STAFF RECOMMENDATION

2625 Essex Place

February 19, 2014

Application: Demolition; New construction - Infill

Current buildings proposed to be demolished.

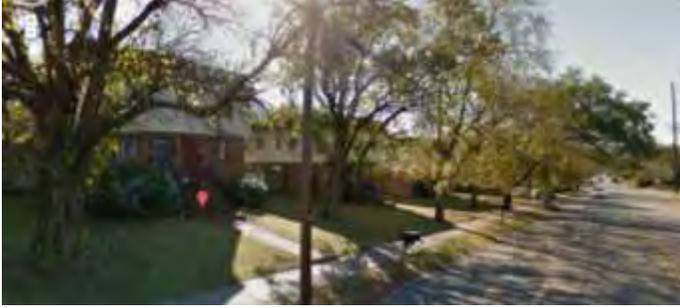
The structures currently at 2623 Essex Place and 2116 Natchez Trace do not contribute to the historic character of the neighborhood. The project meets section III.B.2 for appropriate demolition and does not meet section III.B.1 for inappropriate demolition.

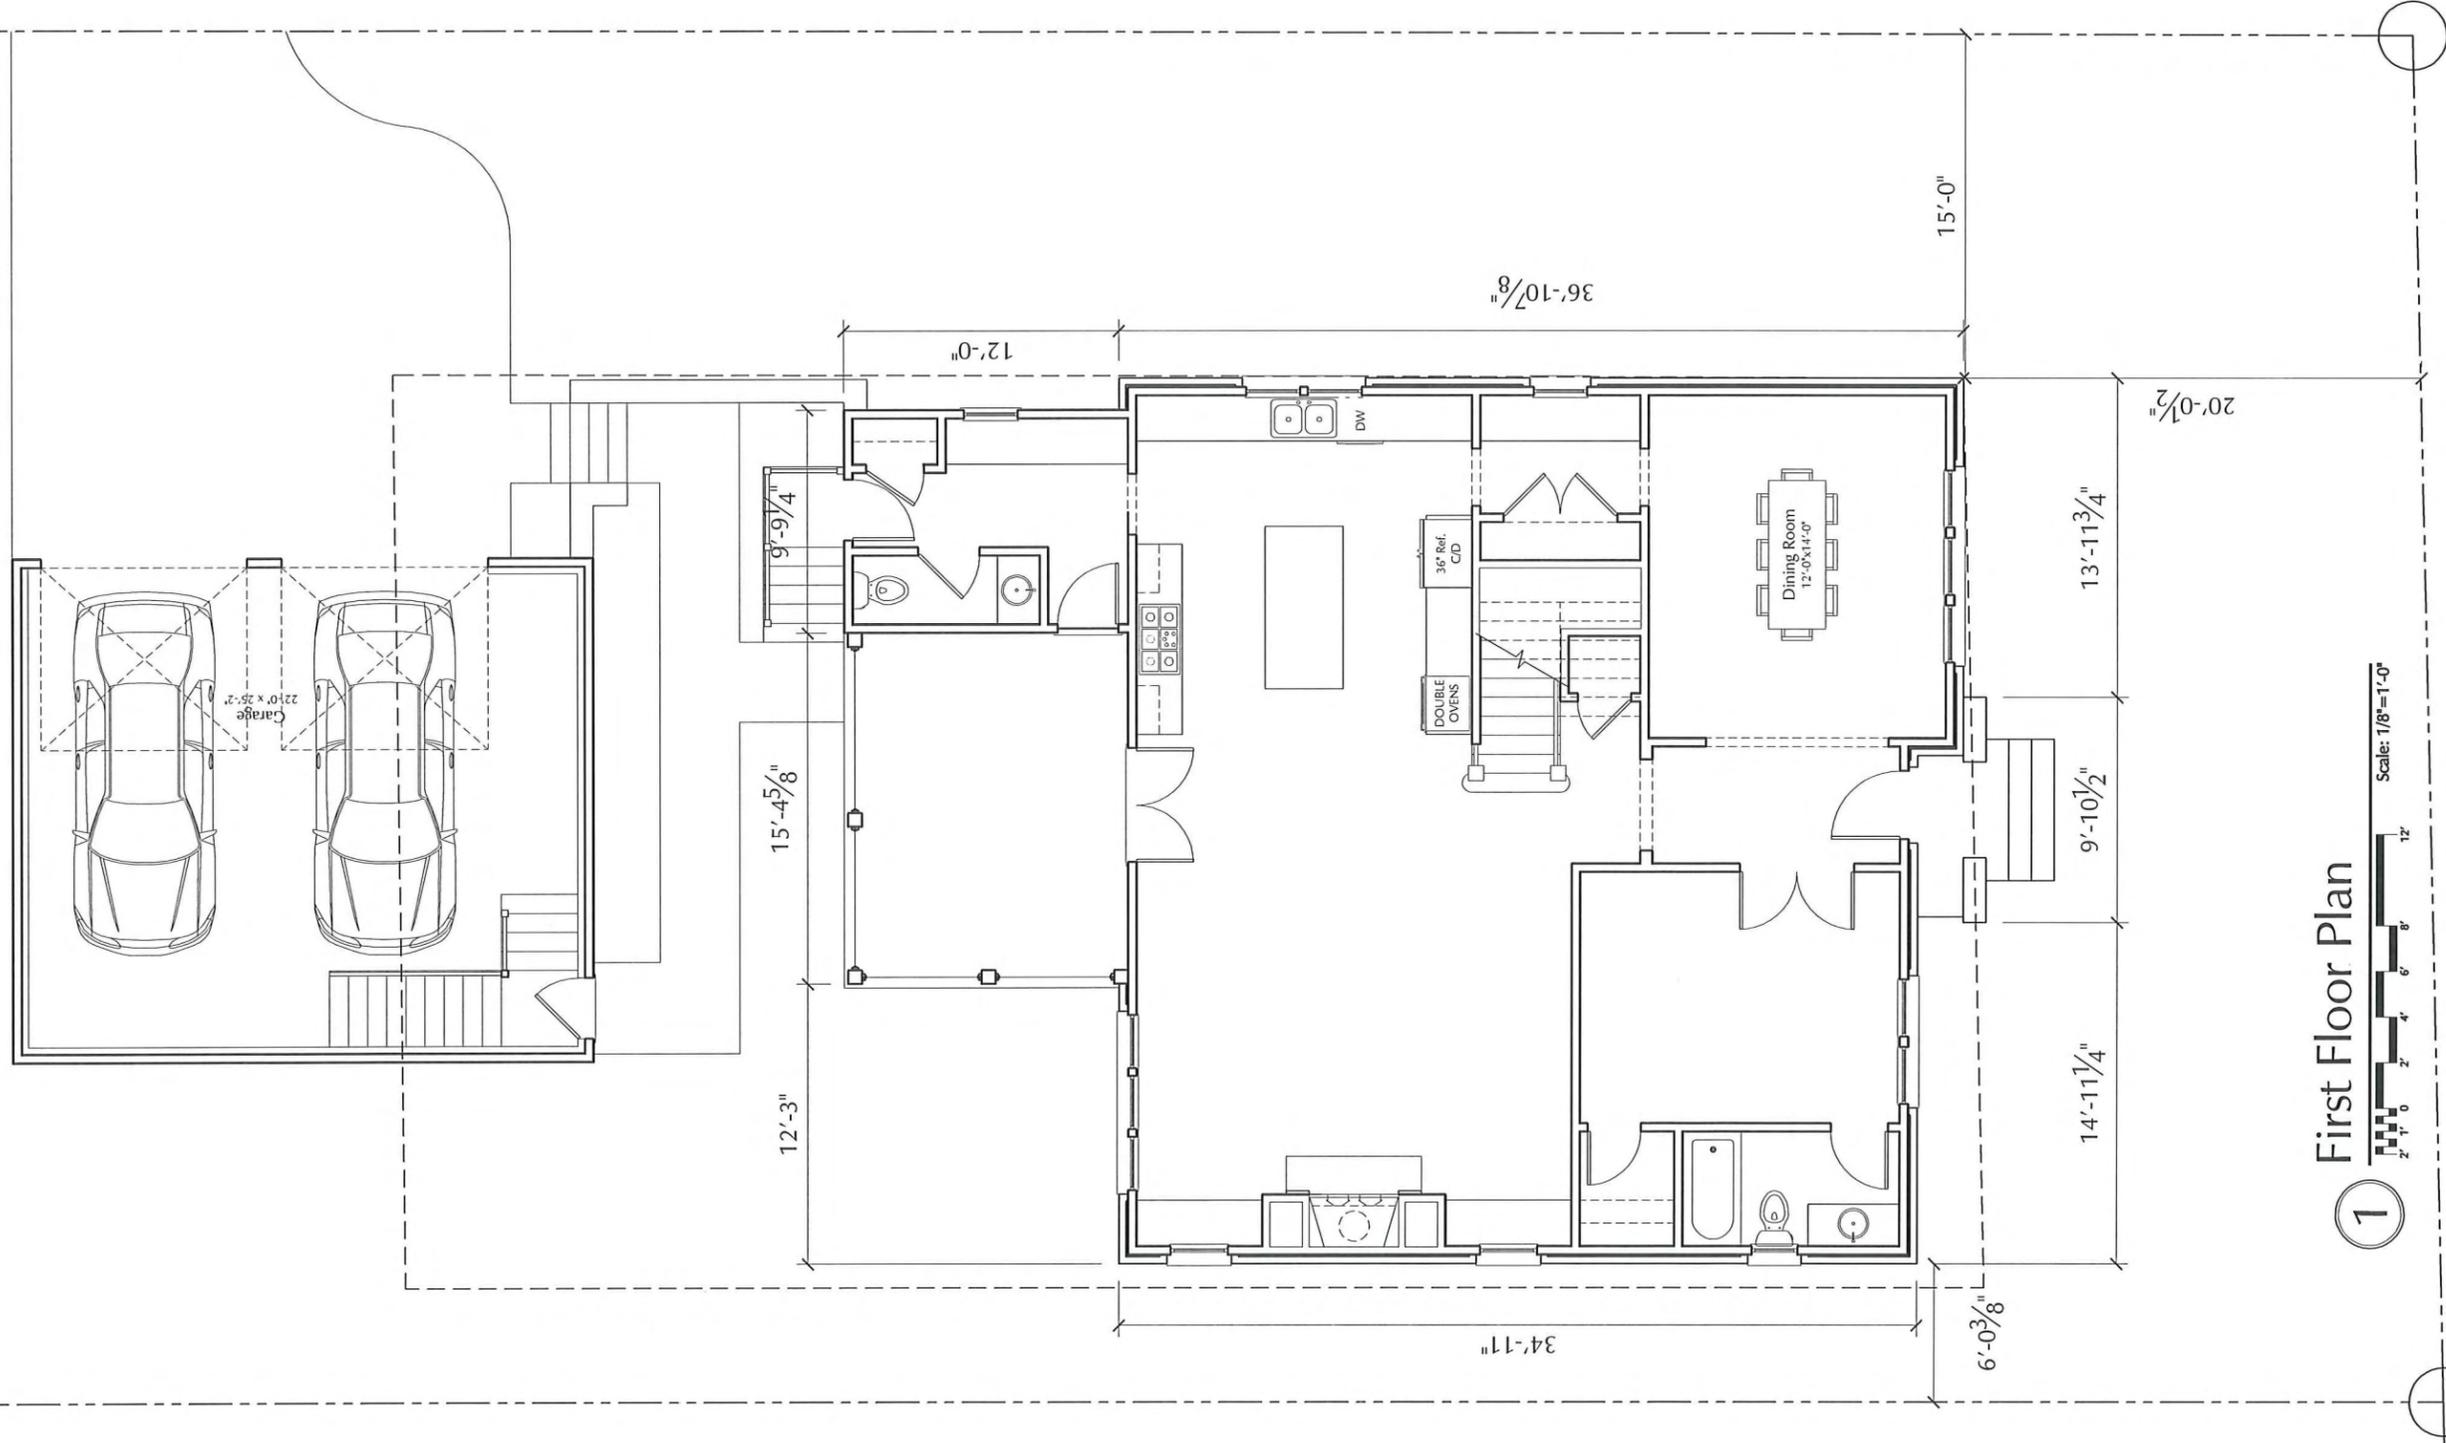
Background: The properties listed as 2623 Essex Place, 2116 Natchez Trace, and 2118 Natchez Trace currently have three non-contributing two-story duplexes that face Natchez Trace. The East-West property line between the two northern lots will be reoriented to North-South so that they both face Essex, with the rear halves of the lots becoming 2623 Essex Place and the front halves becoming 2625 Essex Place. Staff found this orientation to be appropriate as it follows the earlier development of the neighborhood. This project is for building "B" on the site plan. Although a garage is shown on the site plan, the design of it is not a part of this review.

The new house will have a six foot (6') setback on the left side, and a fifteen foot (15') setback on the right along Natchez Trace. The twenty-foot (20') proposed setback is in keeping with the front setbacks of historic houses on the block which vary between as little as fifteen feet (15') to as much as thirty feet (30'). The rear of the building will be twenty-five feet (25') from the rear of the property. This is shorter than rear setbacks in the neighborhood typically, but appropriate because this lot is only two-thirds the depth of a typical lot. These setbacks are compatible with those of surrounding houses, and will maintain the established rhythms of both streets. The project meets guideline II.B.1.c.

The new house will be located with the front parallel to the Essex Place right of way, with a primary entrance facing Essex Place. This orientation matches the historic context, and the front setback is compatible with those of surrounding houses. The proposal includes a driveway at the rear off of Natchez Trace to access a future garage, but no front walkway. The driveway is necessary as there is no alley access but is kept to one lane at the street as has been required of other projects to preserve walkability of the neighborhood and meet the historic context. A walkway should be added to address the front street in the manner typical of historic houses nearby. With the addition of a walkway, Staff finds that the project meets guideline II.B.1.f.
